APPLICATION FOR MODIFICATION ASSESSMENT REPORT

Application Number:	Mod2020/0139
----------------------------	--------------

Responsible Officer:	Jordan Davies
Land to be developed (Address):	Lot CP SP 11874, 5 Commonwealth Parade MANLY NSW 2095
Proposed Development:	Modification of Development Consent DA436/2008 granted for alterations and additions to a residential flat building
Zoning:	Manly LEP2013 - Land zoned R1 General Residential
Development Permissible:	Yes
Existing Use Rights:	No
Consent Authority:	Northern Beaches Council
Land and Environment Court Action:	No
Owner:	Proprietors of Strata Plan 11874
Applicant:	Platform Architects Pty Ltd

Figure 1 - Approved development (left) and proposed development (right) first floor.

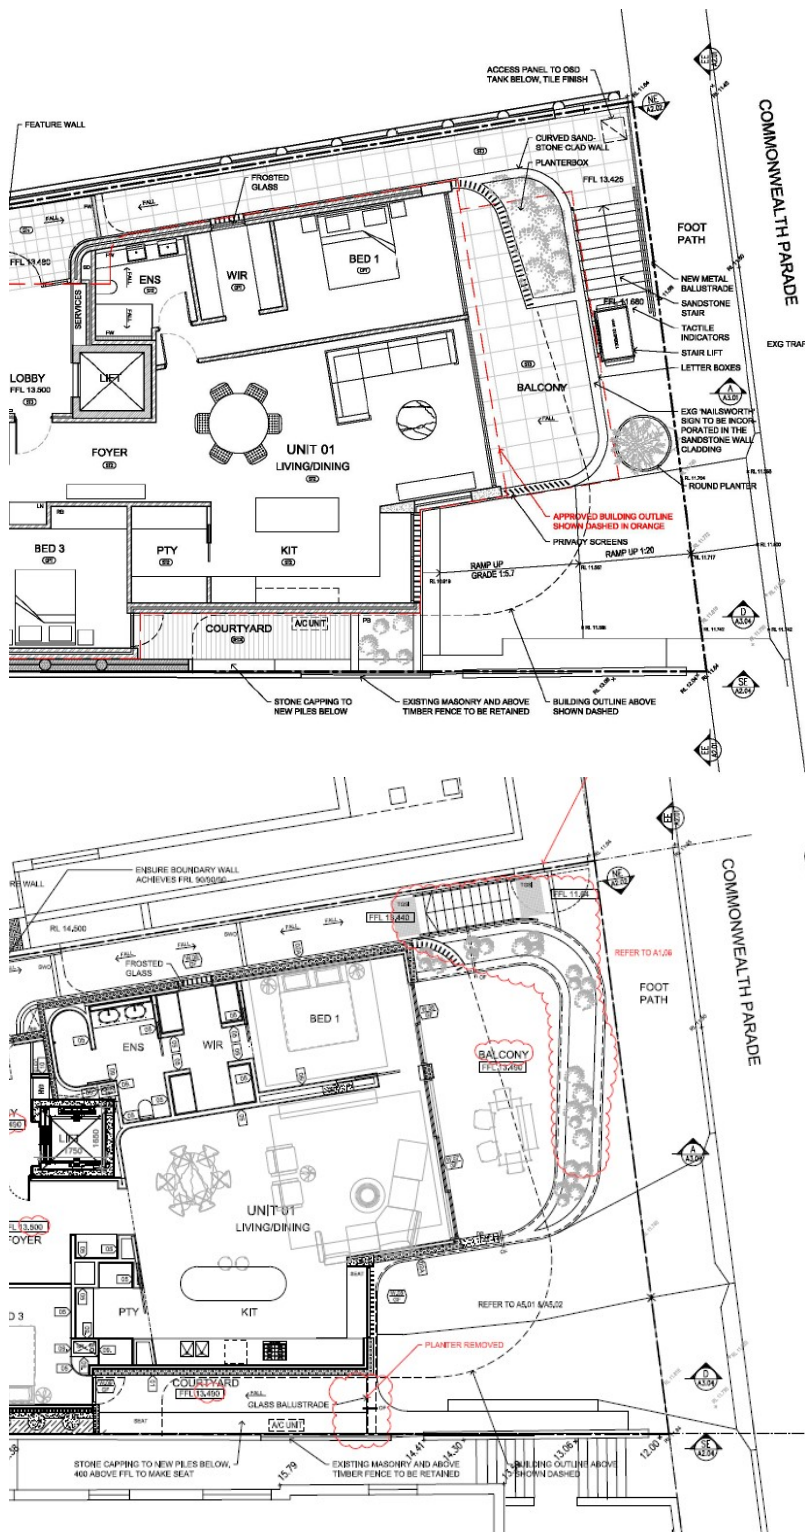
The proposed modifications are consistent with the approved front setbacks for the basement, second floor and third floor. However, the modification involves an amendment to the front balcony setback upon the first floor. The approved front balcony setback is 2.48m, while the proposed modified front balcony setback is 1.2m.

The approved development consists of a zero setback staircase and wall which presents to Commonwealth Parade. The modification involves removal of this staircase arrangement and simplifying the stair access to the site down the northern boundary, rather than across the front boundary. In response to the staircase relocation, the front balcony setback is reduced. However, the protrusion of the first floor balcony is not considered to result in a negative streetscape outcome and is

consistent with the sandstone walls along the front boundary of 7 Commonwealth Parade. A planter box is provided around the balcony to allow softening of the built form upon the street.

Council's Urban Design Officer has reviewed the proposal and supports the changes with regard to the streetscape outcome.
